SUBJECT: WATTS BAR UNIT 1 - NRC STAFF POSITION ON THE QA RECORDS CAP  
(TAC M71923)

NRC STAFF POSITION REGARDING THE  
WATTS BAR QA RECORDS CORRECTIVE ACTION PROGRAM

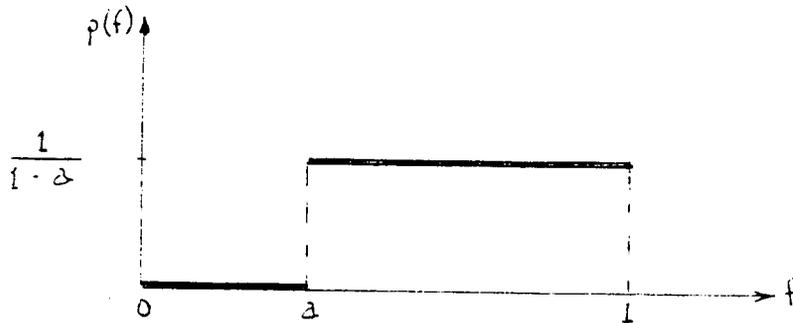
As will be demonstrated, one crucial parameter of a prior for  $f_i$  is its lower truncation point. This is a number  $a$ ,  $0 \leq a < 1$ , such that the prior is zero for  $f_i \leq a$ . In other words, the probability is zero that  $f_i \leq a$  and is positive for all  $f_i > a$ . As a simple example, consider the class of flat priors for a defect fraction  $f$  defined by

This is sketched below.

From these results, it can be seen that the required sample size is a sensitive function of the lower truncation point as it increases towards 0.05. Although the use of a flat prior may not be realistic for the WBN corrective action program, it is clear from this example that the Bayesian sample size will be a sensitive function of the choice of prior. Since the choice of a prior, particularly its lower truncation point, is highly subjective, the NRC will not be able to validate the Bayesian approach.

It is the staff's position that TVA should adopt a classical statistical approach to meet the acceptance criteria of 95/5; the Bayesian approach is not acceptable.
